Service Bulletin: SB 32

GAME: Terminator 2

SUBJECT: Terminator 2 Gun Handle Modification.

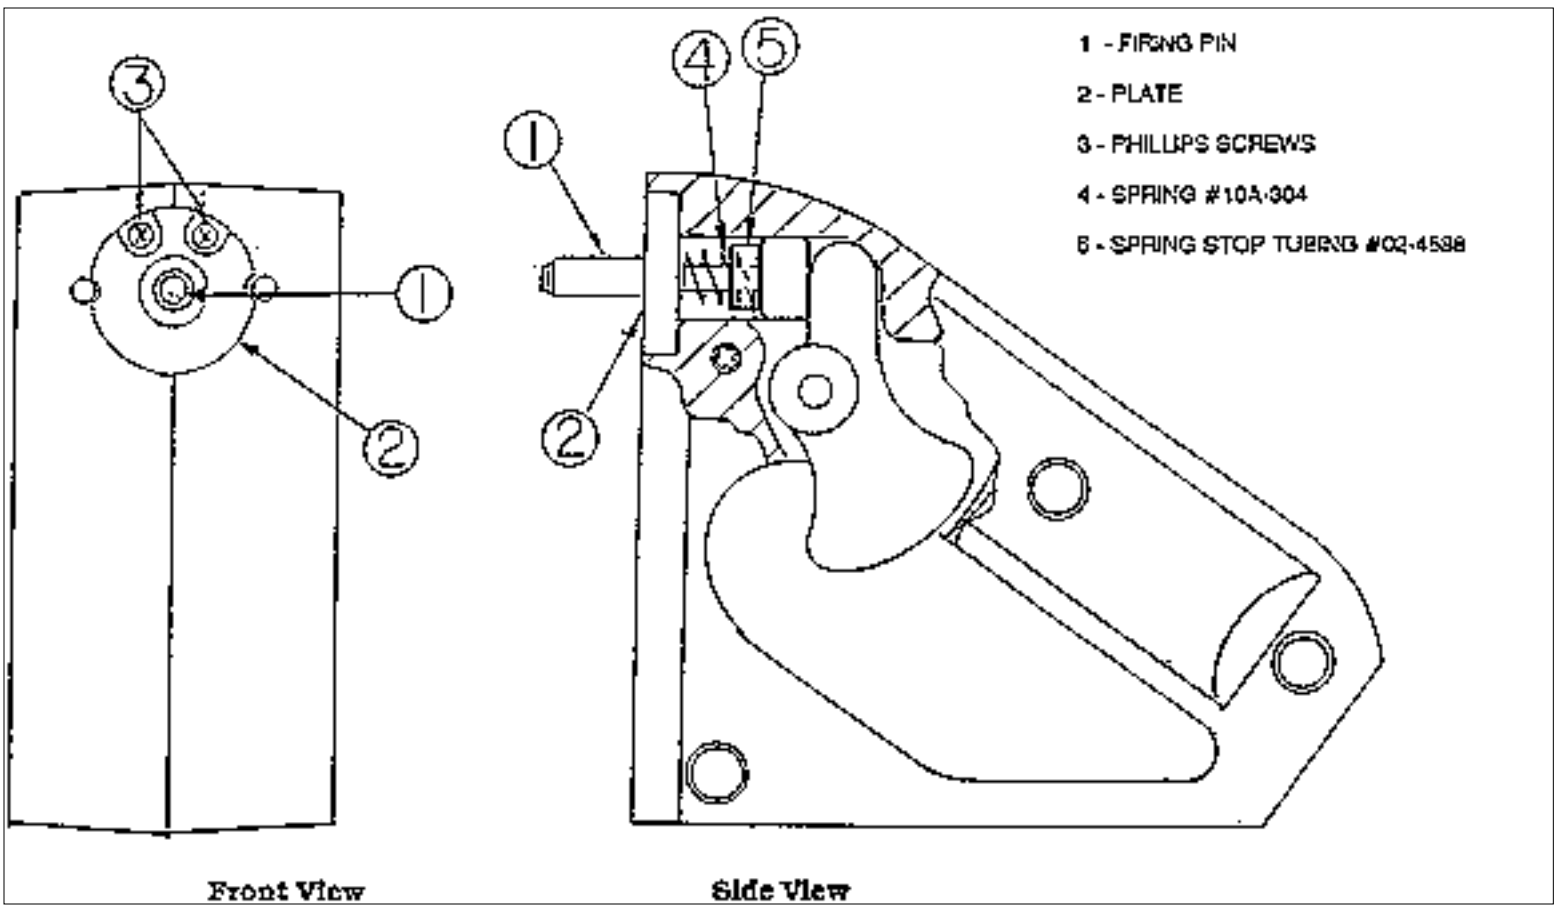
INFORMATION: IF YOU EXPERIENCE BINDING OF THE GUN TRIGGER, ADD A SPRING STOP TUBING (PART # 02-4588).

3. HOLD THE ASSEMBLY SO THE FIRING PIN AND THE PLATE SURROUNDING IT FACES YOU. REMOVE THE TWO PHILLIPS SCREWS HOLDING THE PLATE. REMOVE THE PLATE.
4. DROP THE SPRING STOP TUBING OVER THE SPRING AND FIRING PIN. REPLACE THE PLATE AND THE TWO PHILLIPS SCREWS. SQUEEZE THE TRIGGER TO BE SURE THE FIRING PIN EXTENDS OUT OF THE ASSEMBLY.

5. REATTACH THE GUN HANDLE ASSEMBLY TO THE GAME CABINET. NOTE: YOU MAY HAVE TO READJUST THE GRIP TRIGGER SWITCH (#34).
6. LOWER THE PLAYFIELD, REPLACE THE STEEL BALLS, THE PLAYFIELD GLASS, AND THE FRONT MOLDING. LOCK THE FRONT MOLDING. CLOSE AND LOCK THE COIN DOOR. TURN THE GAME BACK ON
